Addendum # 3
Project 2306
26th Avenue East and London Road Water Main Relocation

26TH AVE E & LONDON RD WATER MAIN RELOCATION

CITY PROJECT NO.: 2306

DRAWN BY: JAI
WATERMAIN PLAN AND PROFILE 2
SHEET NO. 16 OF 40

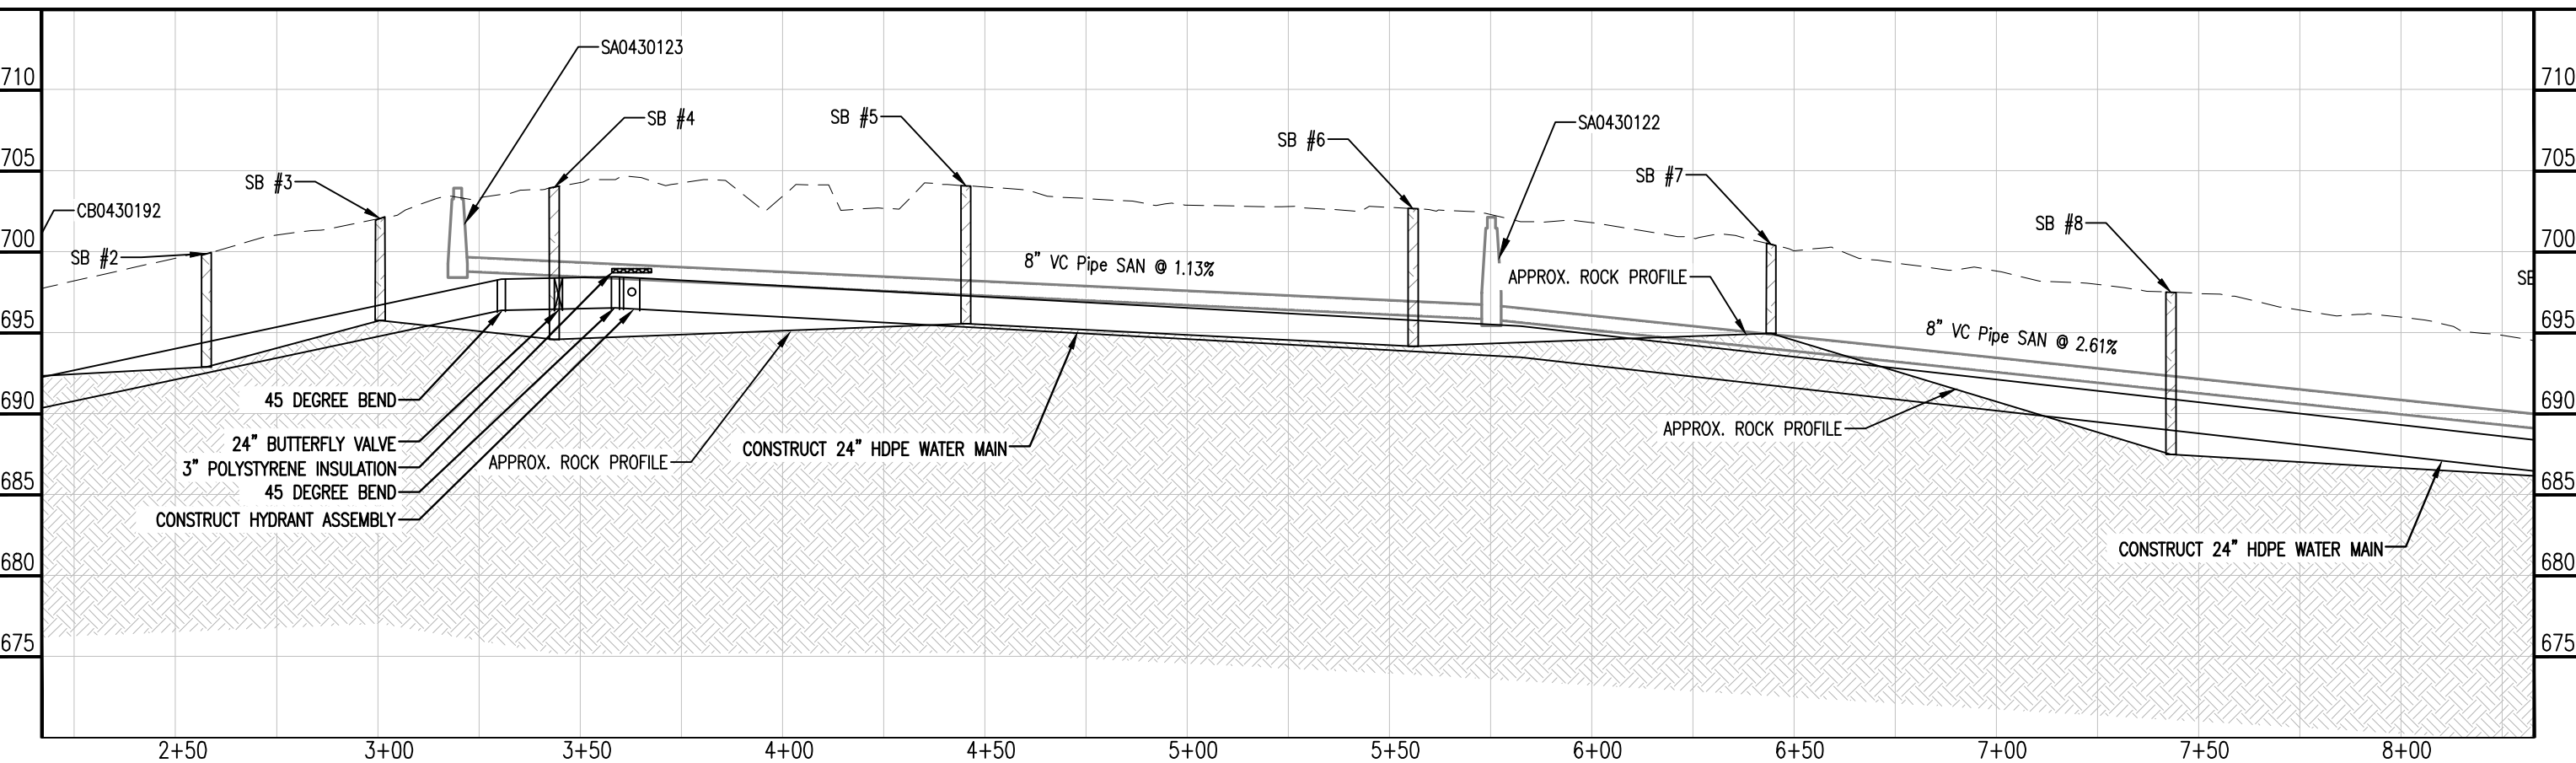
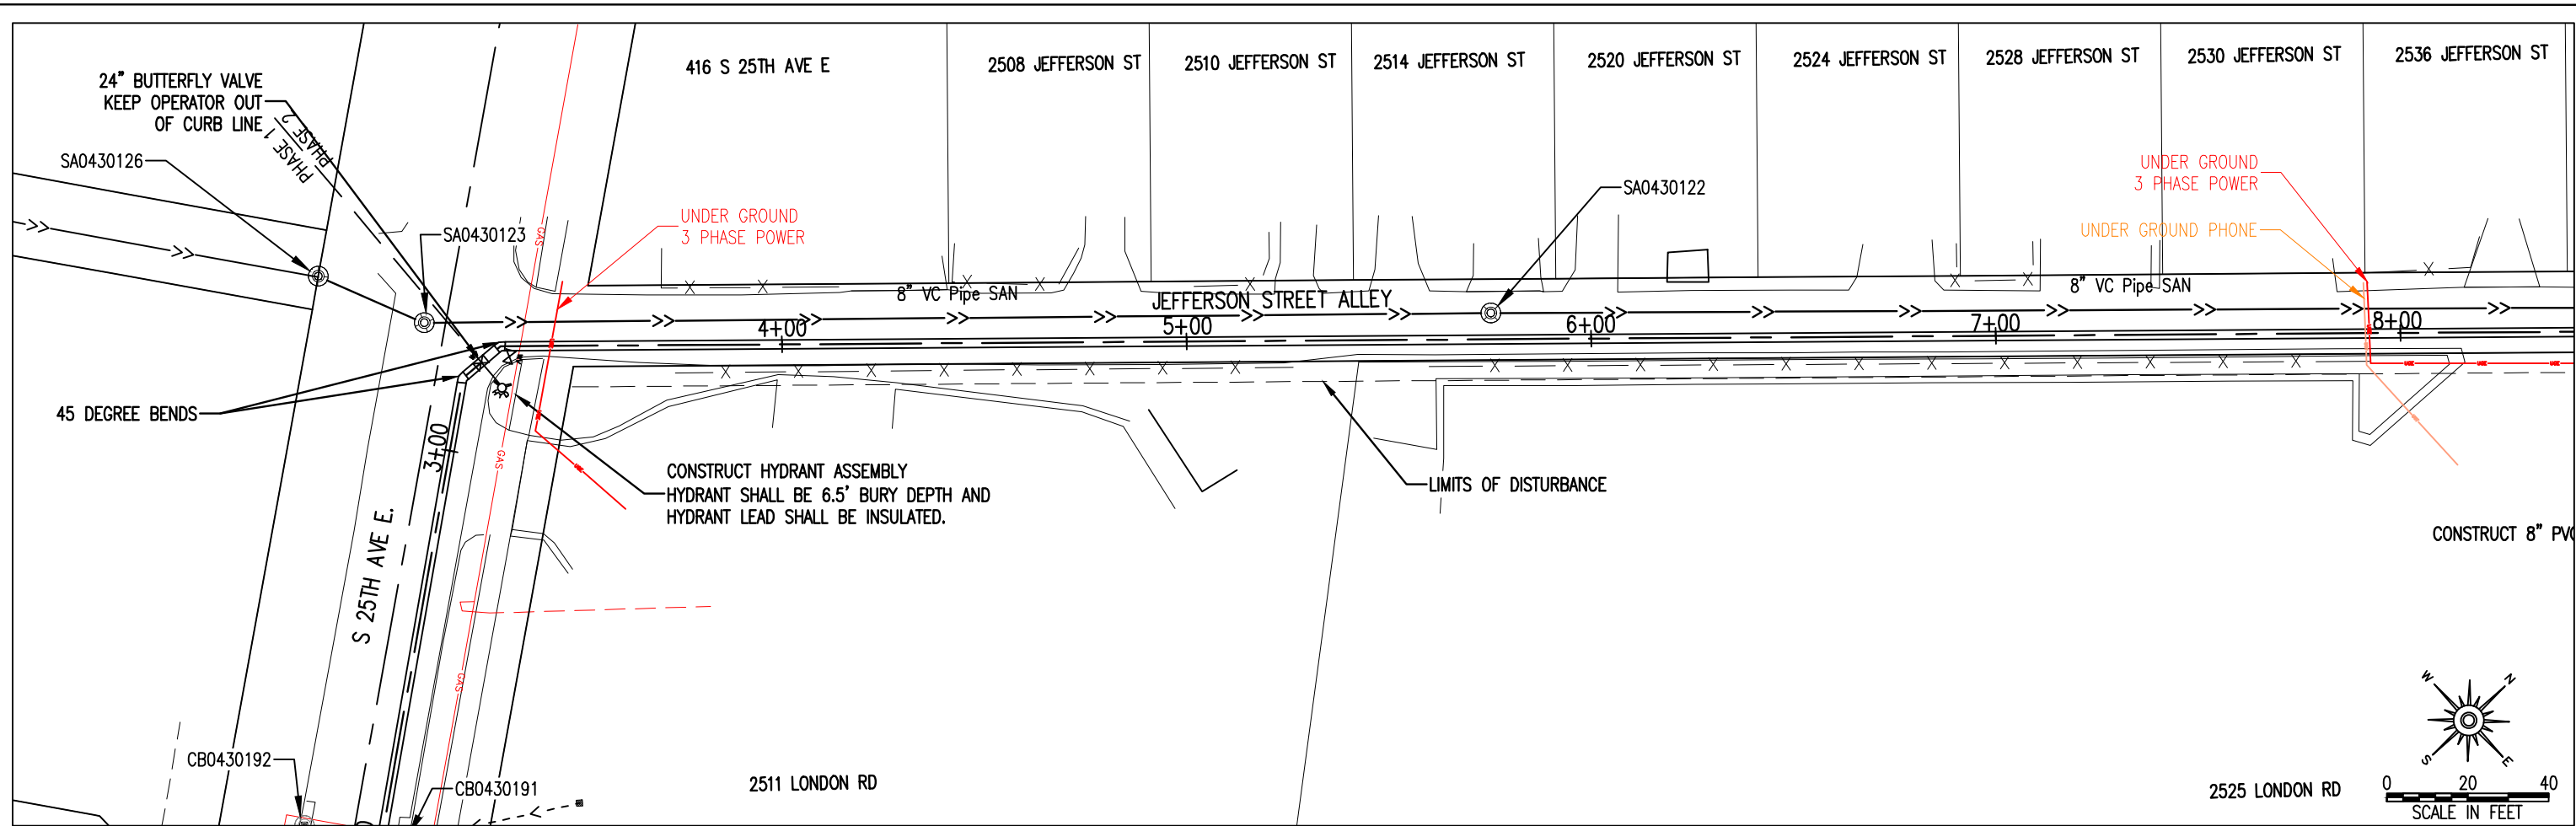
Plan sheet 16 of 40 has been updated to show 3rd party utility crossings of Jefferson Street Alley.
